ZONING BOARD OF APPEALS
CITY OF NOVI
Community Development Department
(248) 347-0415

Case No. PZ13-0042 Tom's Bar & Grill

PLAN REVIEW CENTER REPORT

JSP13-45

PRELIMINARY SITE PLAN

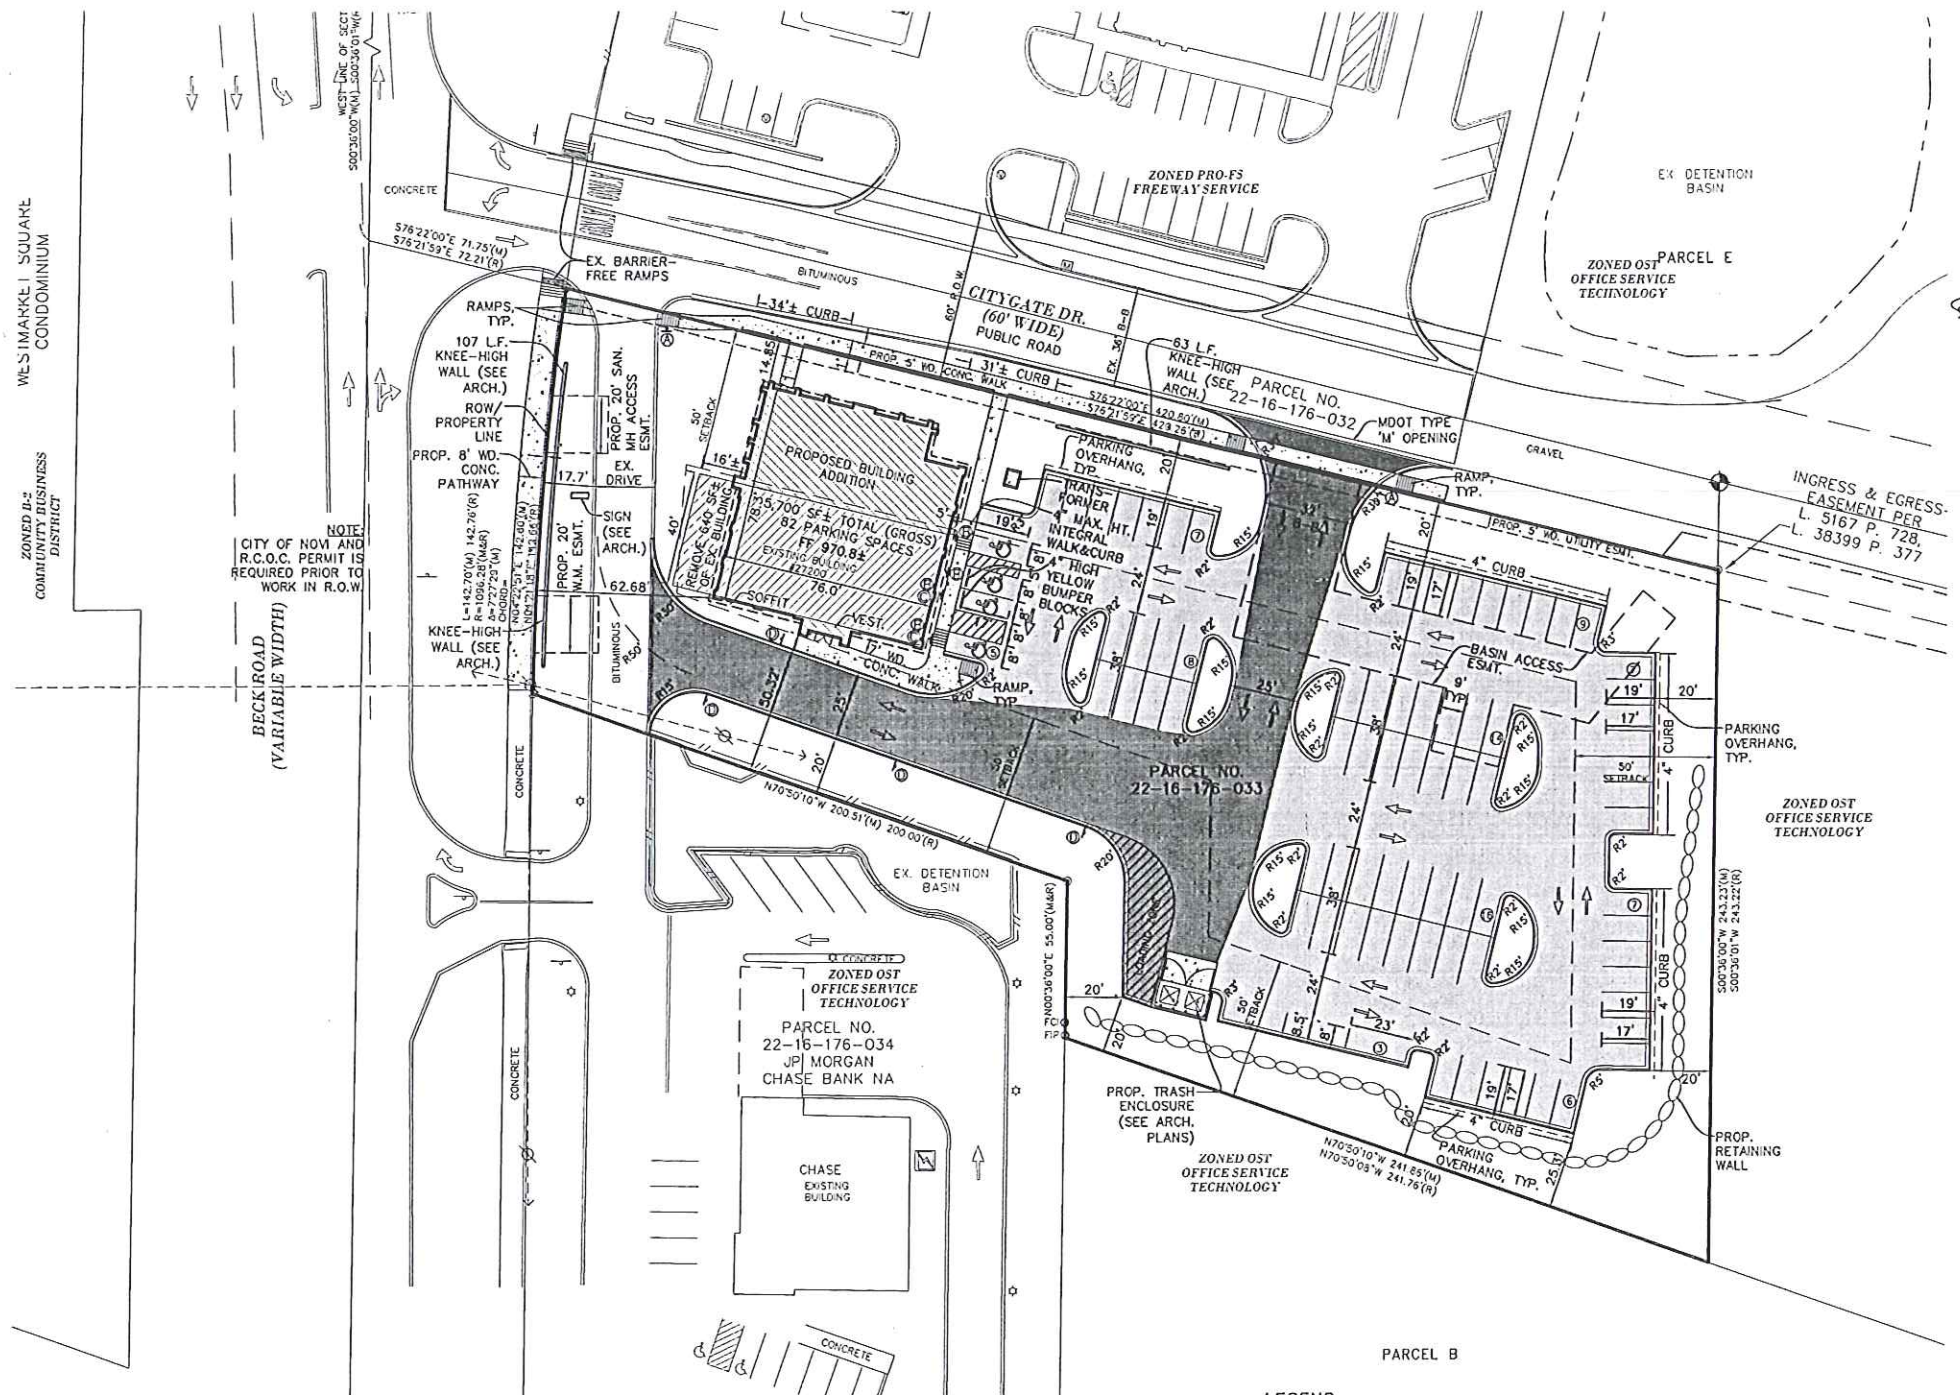
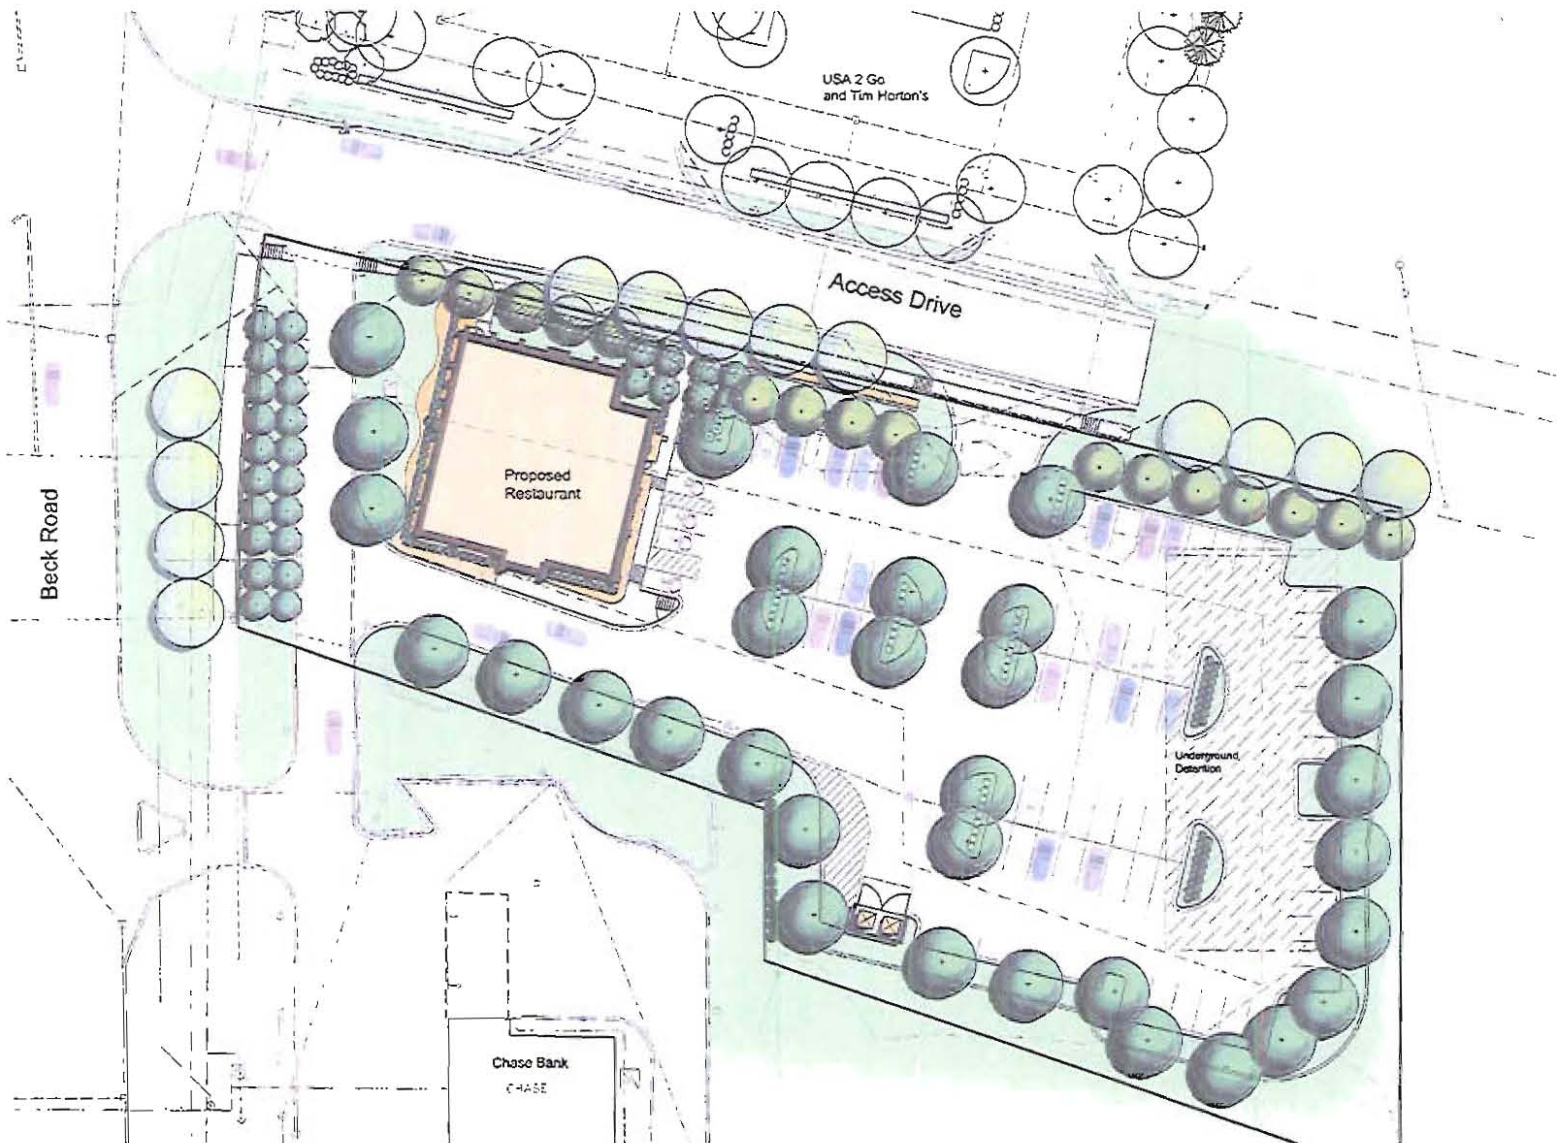
2. Building Setbacks: Buildings in the OST District must be setback 50 feet from all property lines. The plan indicates a 15 foot building setback in the northern yard. **The applicant has indicated they will seek a variance from the Zoning Board of Appeals for this deficiency.**

4. Parking Space Dimensions: A 7 foot sidewalk is required in areas adjacent to 17' parking spaces. **The applicant should include a 7 foot sidewalk adjacent to the proposed barrier free spaces.**

5. Sidewalks: The 5 foot sidewalk proposed along Citygate Drive does not extend to the eastern property line. A sidewalk is required along this entire road frontage. Citygate Drive has not been extended to the subject property's eastern-most border at this time. **The applicant should either extend the sidewalk to the eastern property line or provide funds in an escrow account for the extension of the sidewalk at a future date.** See the traffic review letter for additional information.

Building Setbacks (Section 2400)				
Front (west)	50 feet	62 feet	Yes	
Exterior Side (north)	50 feet	15 feet	No	The applicant has indicated they will seek a variance from the Zoning
